Customer : CU-DAR001 Dart Helicopters Services Drawing Name : HELI UTILITY BASKET LH/RH 350/355
 Job Number : 32521
 Estimate Number : 10208
 P.O. Number : N/A Part Number : D350607043
 This Issue : 5/23/2007 S.O. No. : N/A Drawing Number : D350-607 REV F P7-9
 Prsht Rev. : NC Project Number : N/A
 First Issue : N/A Type : LARGE FAB ASSY Drawing Revision : F
 Previous Run : 32520 Material : N/A
 Written By : Due Date : 6/6/2007 Qty: 1 Um: Each
 Checked & Approved By : 07.05.24
 Comment : Est Rev:E as Per DSI9318 06-01-24 JLM

DESIGN <i>CP</i>	DRAWN BY <i>CP</i>	DART AEROSPACE LTD HAWKESBURY, ONTARIO, CANADA	
CHECKED <i>[Signature]</i>	APPROVED <i>[Signature]</i>	DRAWING NO. DSI 9318	REV. A SHEET 1 OF 1
DATE 06.01.06		TITLE WASHER ADDITION	SCALE NTS
A	06.01.06	NEW ISSUE

DART SERVICE INSTRUCTION

TO AMEND INSTALLATION INSTRUCTIONS D350-607 REV. F

Figure 5- Basket Replacement Parts
(D350-607-043 Heli-Utility-Basket™)

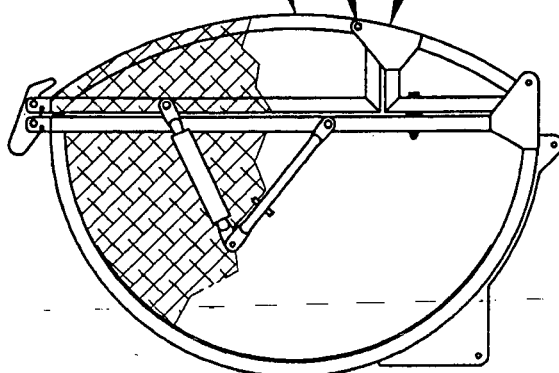
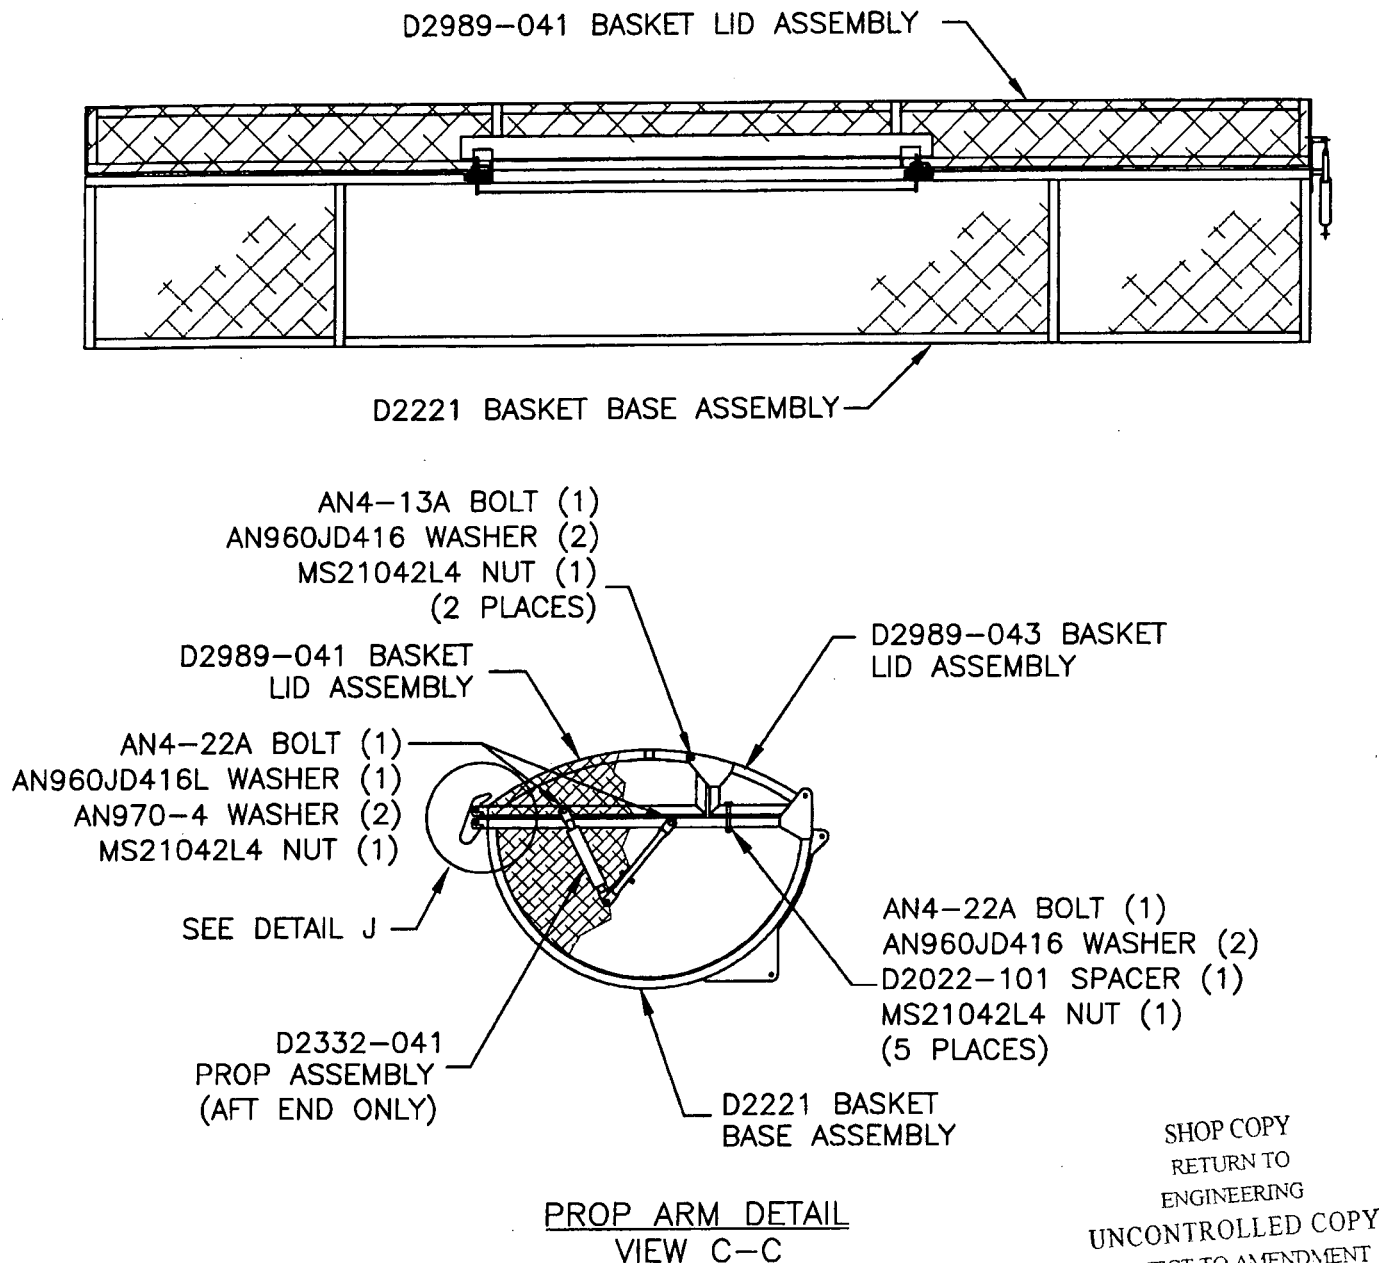
To reduce the possibility of damaging the finish, a **NAS1515H4** washer (2 places) has been added between the hinge plate and basket frame on the **D350-607-043/-047 Heli-Utility-Basket**.

The corrected bolt stackup from Figure 5 of installation instructions D350-607 Rev. F is given below:

AN4-13A BOLT (1)
AN960JD416 WASHER (1)
HINGE PLATE (REF)
NAS1515H4 WASHER (1)
BASKET FRAME (REF)
AN960JD416 WASHER (1)
MS21042L4 NUT (1)
(2 PLACES)
